CITY OF BLOOMINGTON PLAT COMMITTEE

DP-02-20 **Public Investment Corporation – Theodore Ferguson** 2700 W. Tapp Rd. Request: Final plat approval for a 9-lot subdivision of 14.47 acres. <u>Case Manager: Eric Greulich</u>

Re: Mill Creek Phase 2 Section 1 Final Plat

Mill Creek Phase 2 Section 1 Final Plat Petitioner's Statement

MILL CREEK PHASE 2 SECTION 1 FINAL PLAT

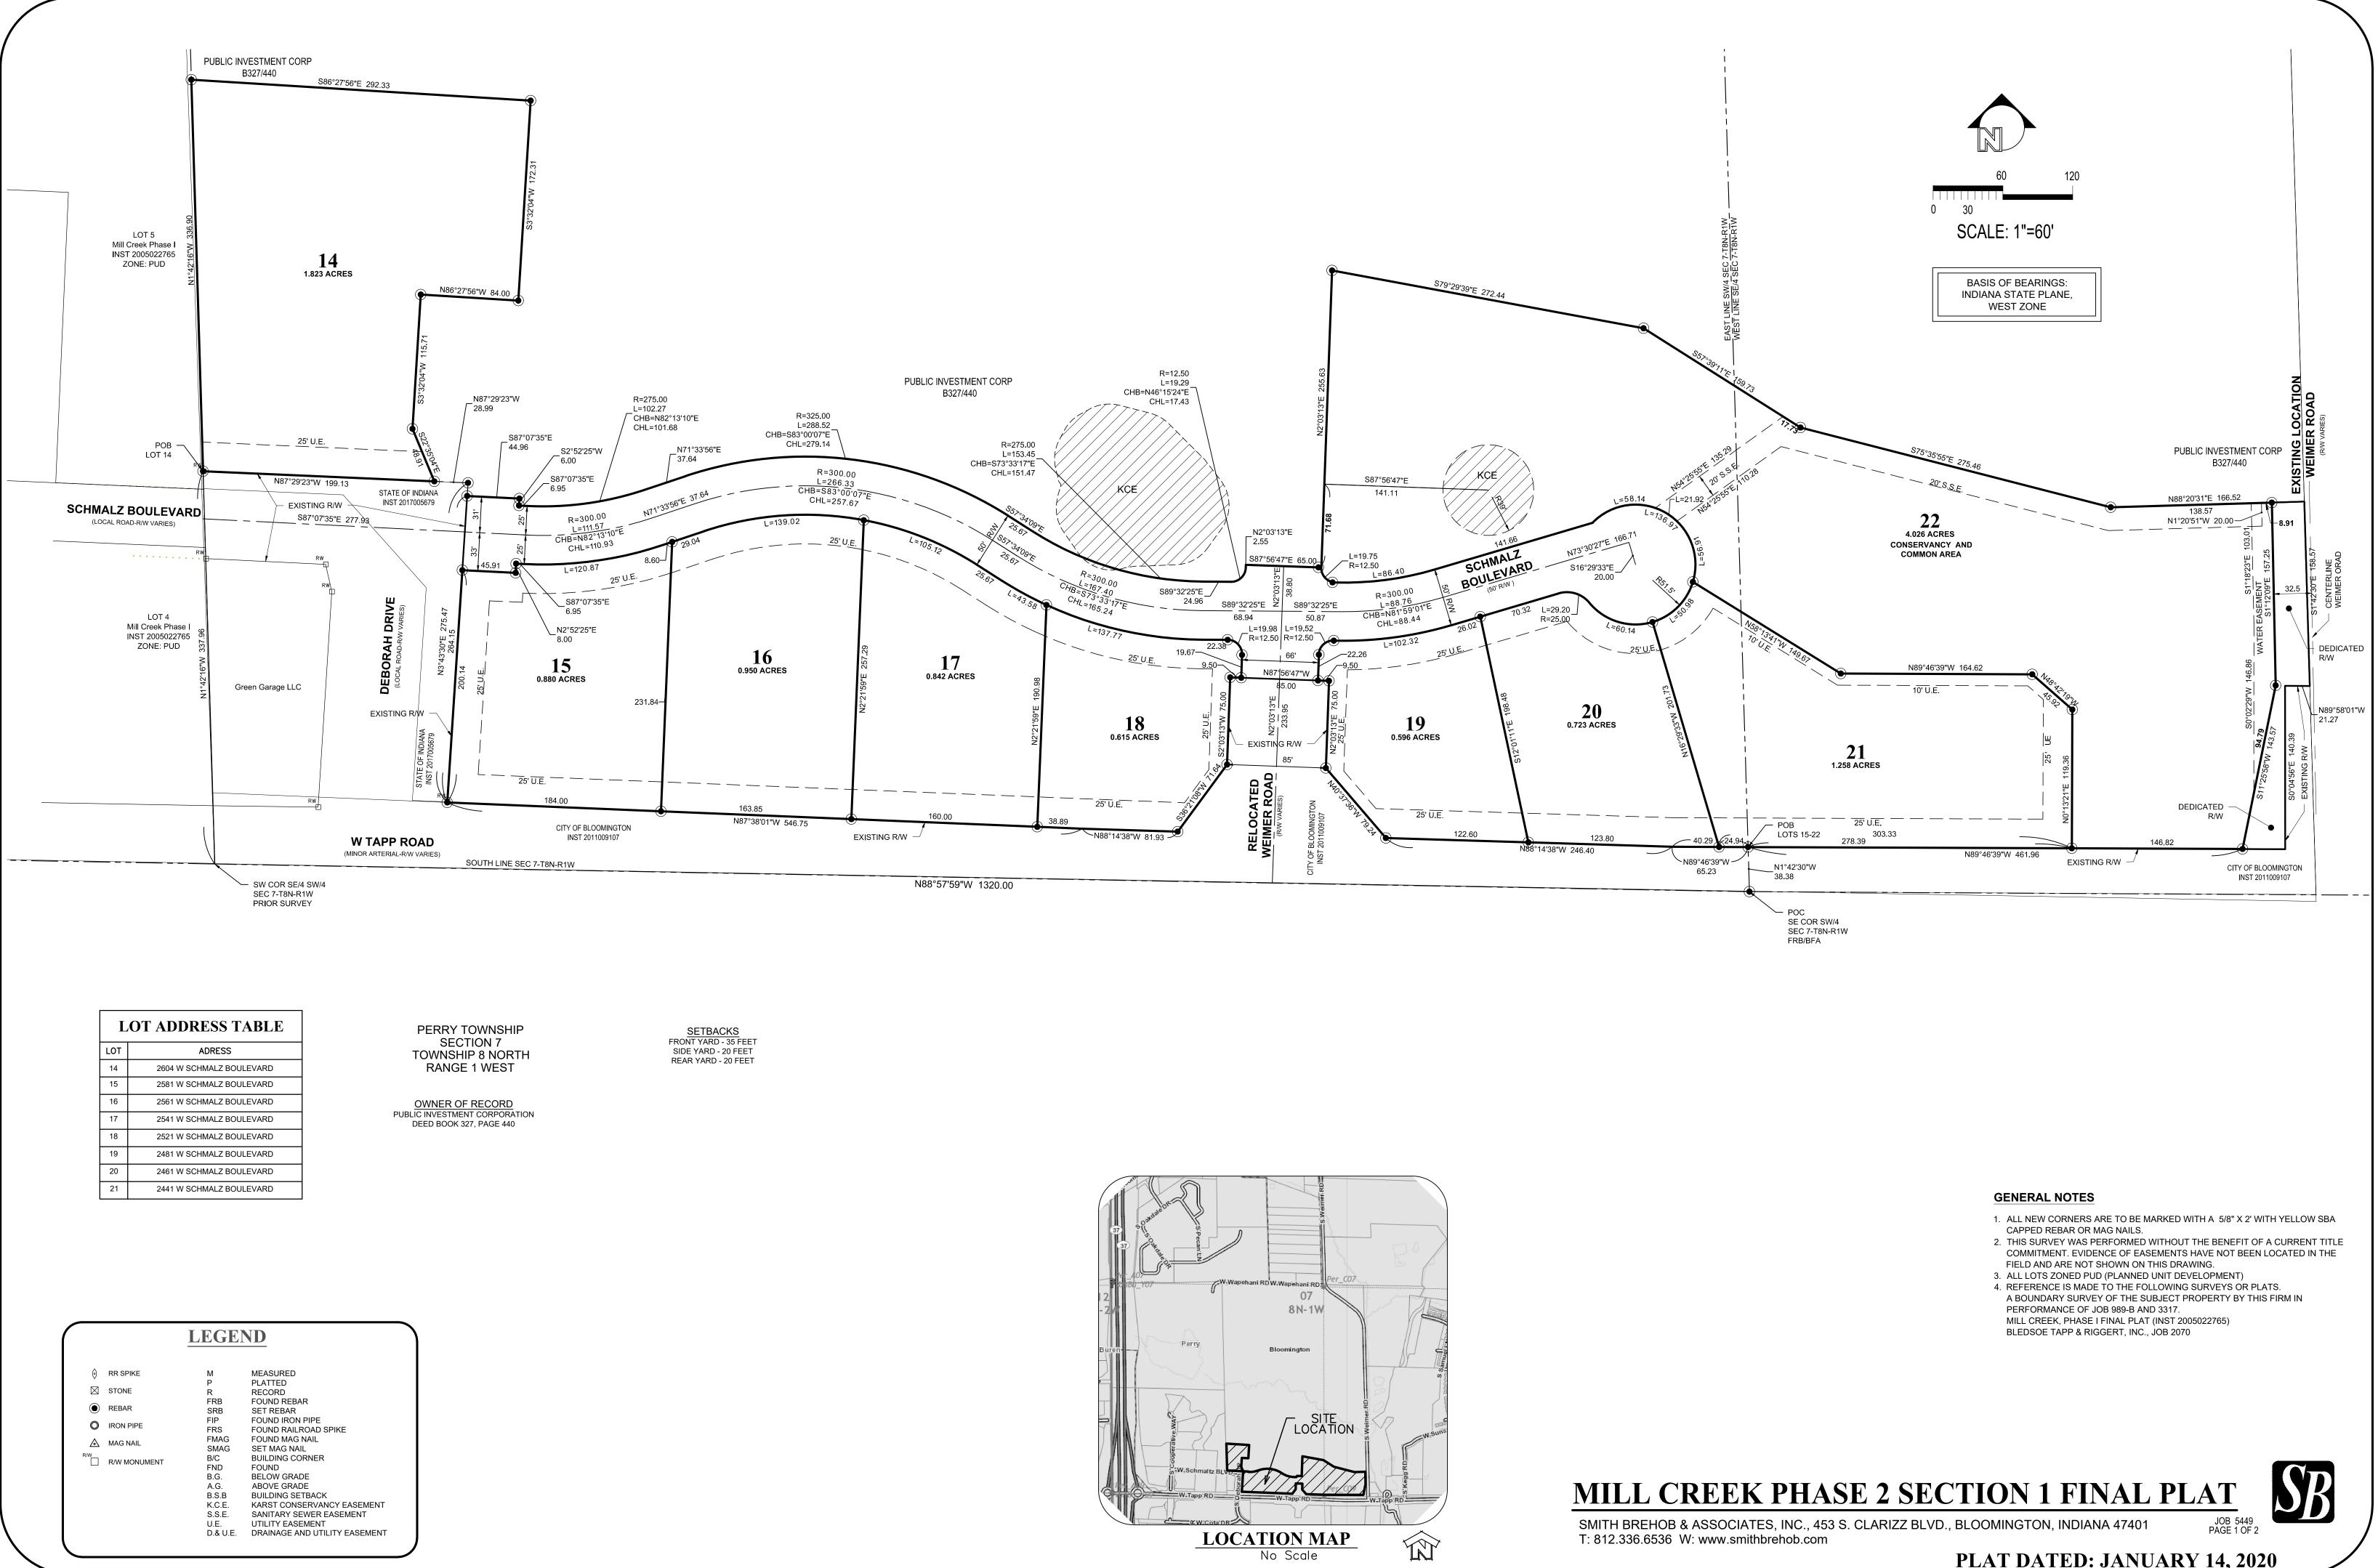
Right-of-Way: With this project, Weimer Road would be relocated west to run through the center of this property. Weimer Rd. would be classified as a Primary Collector and a total of 65' of right-of-way would have been required. However, in order to minimize disturbance through this property, the Plan Commission approved a specific cross-section of this road for this phases with only 60' of right-of-way being dedicated. Future sections of Weimer are required to dedicate the required 65' of right-of-way. In addition, right-of-way dedication from the centerline of existing Weimer Road is required and 32.5' of right-of-way has been shown as required. All internal streets would be public with a total of 50' of right-of-way dedicated for each. All roads will be dedicated public roads. The Department has worked with the petitioner on an appropriate cross section for the new Weimer Road to include bike lanes as well as sidewalks and tree plots. The approved cross sections must be shown on the final plat prior to signature. In addition, the final plat must show all right-of-way clearly dedicated to the City of Bloomington and show centerlines of adjacent roads.

Street Trees: New street trees are required no less than 20' and not more than 40' from center along all internal public streets, as well as along Weimer and Tapp. A 5' wide tree plot with street trees is required along both sides of Schmaltz Drive as well as along the other new streets.

Common Area: There is one common area lot shown on the final plat. The UDO requires that areas of tree preservation over one acre in size be set aside in common area and this has been met with some of the area. The common area lot contain areas of 18% slope that are required to be preserved. A facilities maintenance plan has been submitted and will be recorded with the final plat.

Environmental: The petitioner is meeting the tree preservation requirements with the approved site plan and some of that area is being set aside on the common area lot with this phase. There is one karst features on the site that is required to be set aside in karst preservation easement and has been shown as well. The site also has several areas of 18% slope and those have been set aside within the common area as well.

- 1. Approved cross sections must be shown on the plat prior to signature.
- 2. A facilities maintenance plan must be recorded with the plat.
